RE: Exception to the reduce the approach corner clearance from 85 feet to 10 feet.
Lot 1, Block 2, Rainbow Addition, and Tract A, Block 25, South Boulevard Addition, Rapid City, South Dakota

**REQUEST FOR EXCEPTION TO
RAPID CITY DESIGN STANDARD AND CRITERIA**

PROJECT Sonic Drive-In Restaurant

Preliminary Site Plan
Sonic Restaurant

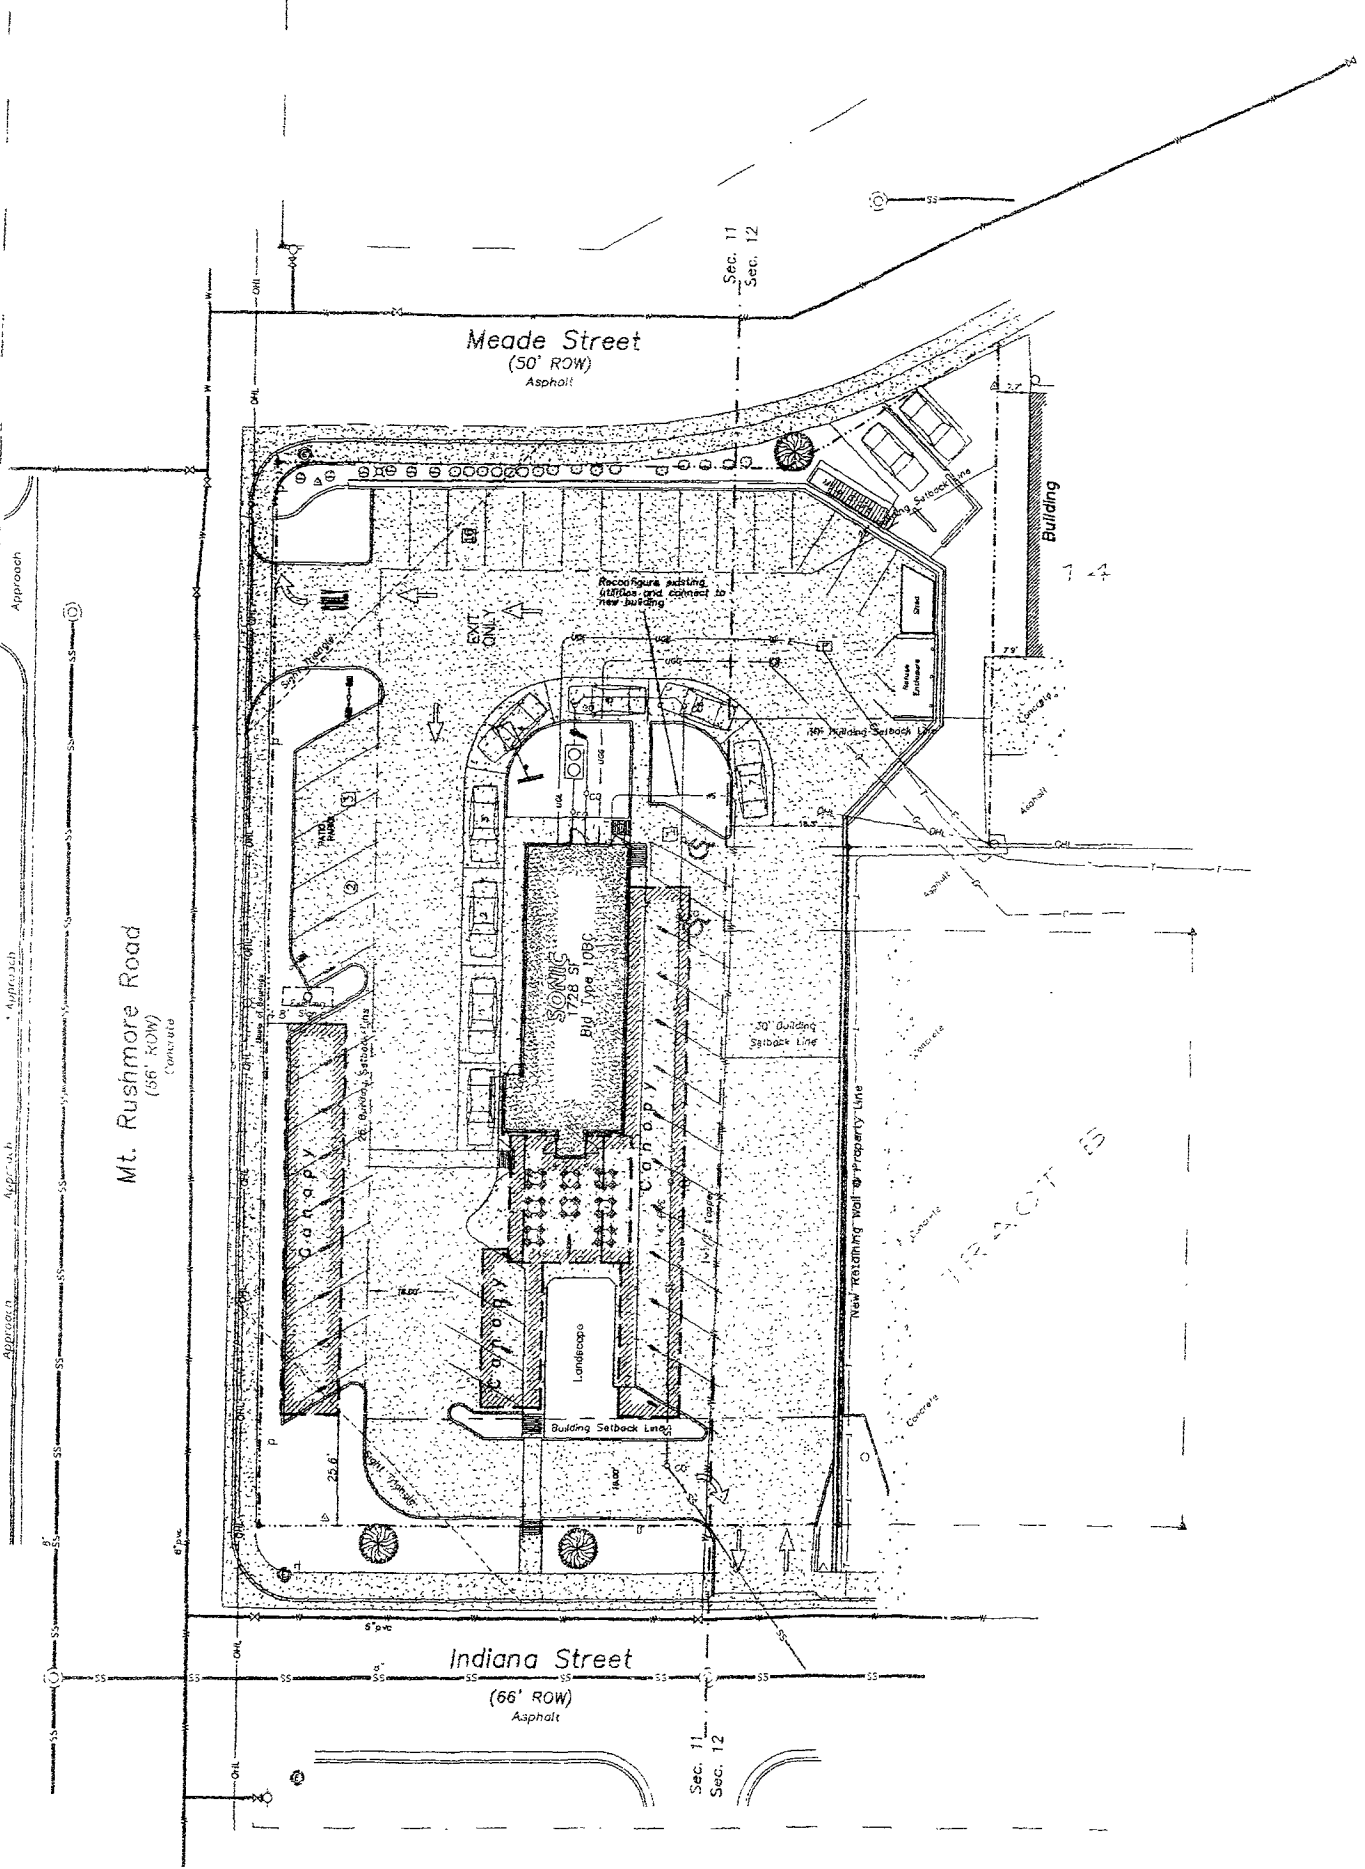
Mt. Rushmore Road is a state highway that has a high volume of traffic especially during the tourist season. A vehicle waiting to turn onto Mt. Rushmore Road from Meade Street may not anticipate a vehicle exiting the proposed approach, therefore resulting in increased crash potential. Congestion may also occur in the center turn lane as vehicles attempt to turn into different approaches within 10 feet of each other.

STAFF COMMENTS: Per figure 8-1 of the SDCA, minimum clearance from curb to 25' curb line extension is 115'. I believe it is not a requirement to obtain an exception to access the higher order street. Access to route Street is not feasible due to the grade differences. The approach would not fit an Indiana this type of business would need both approaches.

Recommend the approach to 14th. Rushmore Road be moved to be in accordance with Figure 8-1. Deny this Request to reduce corner clearances.

The Request for Exception for an exception to waive the requirement to provide the minimum corner clearance for the approach located adjacent to Mt. Rushmore Road is denied. The City of Rapid City Street Design Criteria Manual, Section 8.2.3 and figure 8-1 requires an 85 foot corner clearance from Meade Street at this location. This requirement is for the safety of drivers in this vicinity.
